Mr. James H. Moore Jr.  
Director of Operations  
Rinchem Company, Inc.  
6133 Edith Boulevard N.E.  
Albuquerque, New Mexico 87107

RE: **Technical Review Notice of Deficiency**  
**EPA ID NO. NMD002208627**

Re: RCRA Facility Assessment Report  
Rinchem Company, Inc.,  
NMD002208627

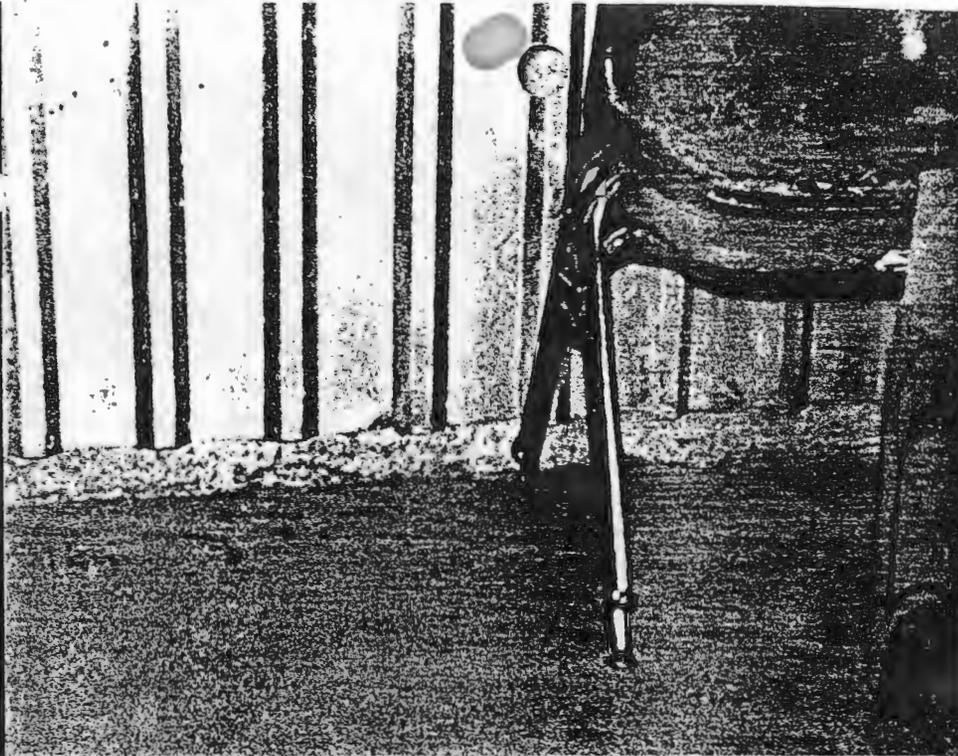
Suggested Action: Regrade the ground around the tanks to ascertain that rainwater will not flow into the unit. The drain pipe from the warehouse should be rerouted away from the tanks. No staining was observed on the tank or floating on the water.

Reasons: During the August 1987 VSI, the 500-gallon tank was nearly filled with rainwater and the larger tank had about an inch of water in it. Surface water from a recent rainstorm appeared to have flowed into the tanks. It may have come from the drain pipe from the warehouse.
